CASE NO. FP-2022-0033

ORDER OF CONDITIONAL
APPROVAL OF FINAL PLAT

STAFF REPORT

SUBJECT: FP-2022-0033
Prescott Ridge No. 3

B. Final Plat (date: 10/5/2022)

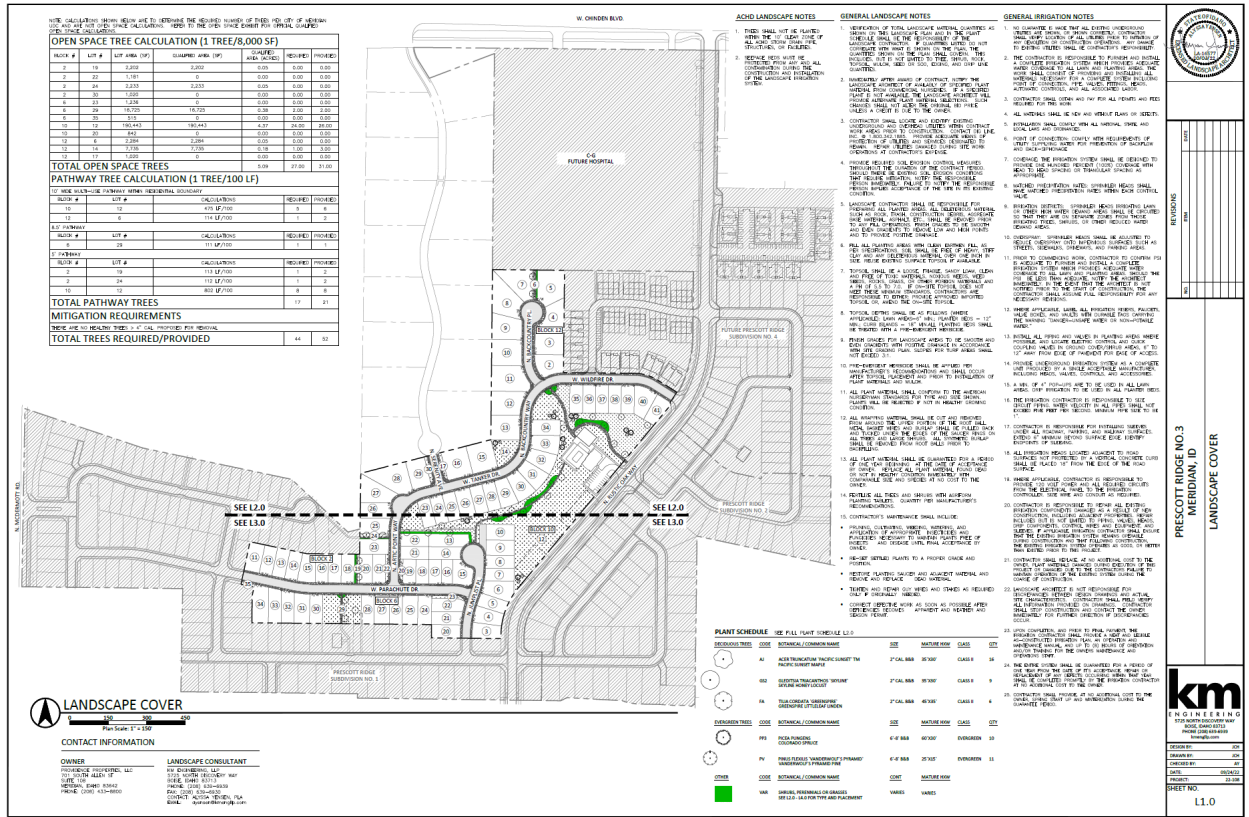
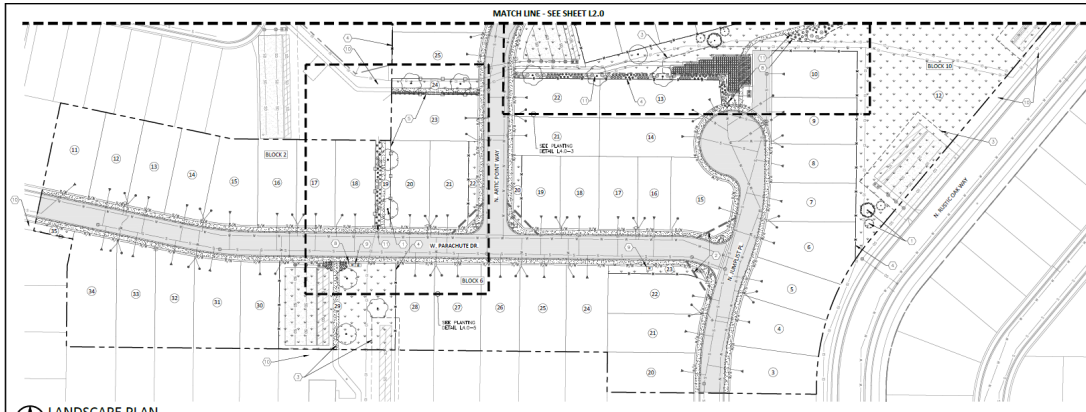
3. Prior to submittal for the City Engineer's signature, have the Certificate of Owners and the accompanying acknowledgement signed and notarized.
4. The final plat shown in Section V.B prepared by KM Engineering, stamped on 10/5/2022 by Aaron L. Ballard, shall be revised as follows:

- a. Note #5: Correct lot and block numbers to coincide with this plat.
 - b. Note #15: Include the recorded instrument number for the ACHD permanent easement.

- c. Note #16: Include the recorded instrument number for the ACHD permanent easement (or delete note if this is a duplicate of note #15).
 - d. Under References, R3 – include the Book and Page numbers of Prescott Ridge Subdivision No. 1.

- e. If the medical facility property to the north isn't able to obtain an access easement for emergency access via Serenity Lane, a private street in Peregrine Heights subdivision to the west, a minimum 20-foot wide emergency access driveway constructed to Fire Dept. standards shall be depicted between Lots 5 and 7, Block 12. *Note: The emergency access isn't required to be functional until the overall area of the building on the site to the north exceeds 124,000 square feet or three (3) or more stories in height; however, the access should be planned for and constructed with the subject plat.*

An electronic copy of the revised plat shall be submitted prior to signature on the final plat by the City Engineer.

E. Common Driveway Exhibit

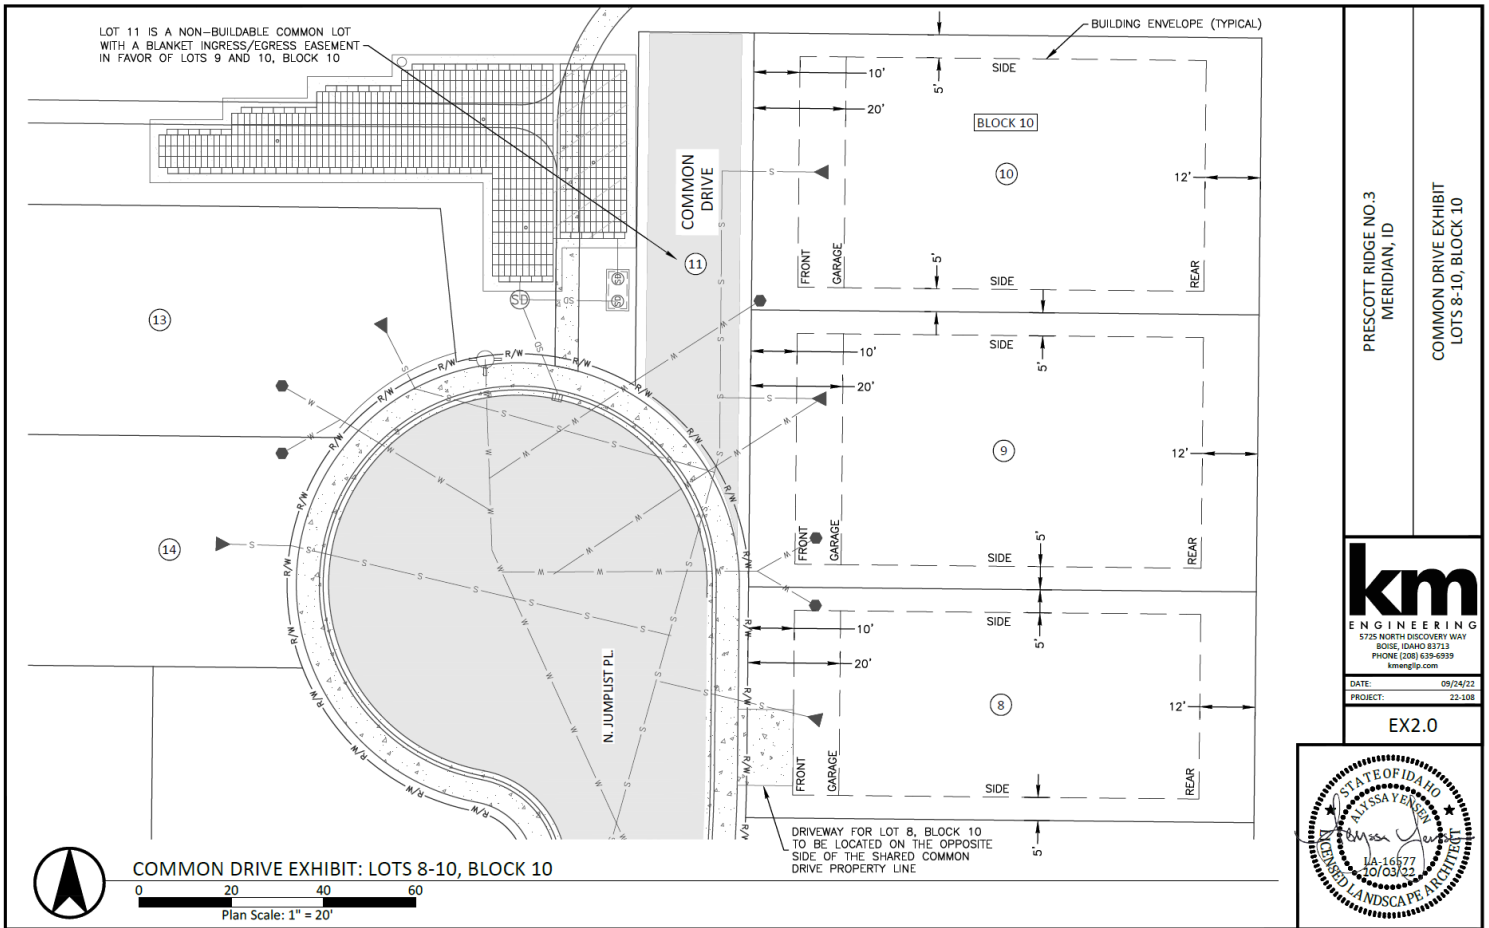
9. Common driveways shall be constructed in accord with the standards listed in UDC 11-6C-3D.
10. Structures on Lots 9 and 10, Block 10 shall comply with the common driveway exhibit in Section V.E above.
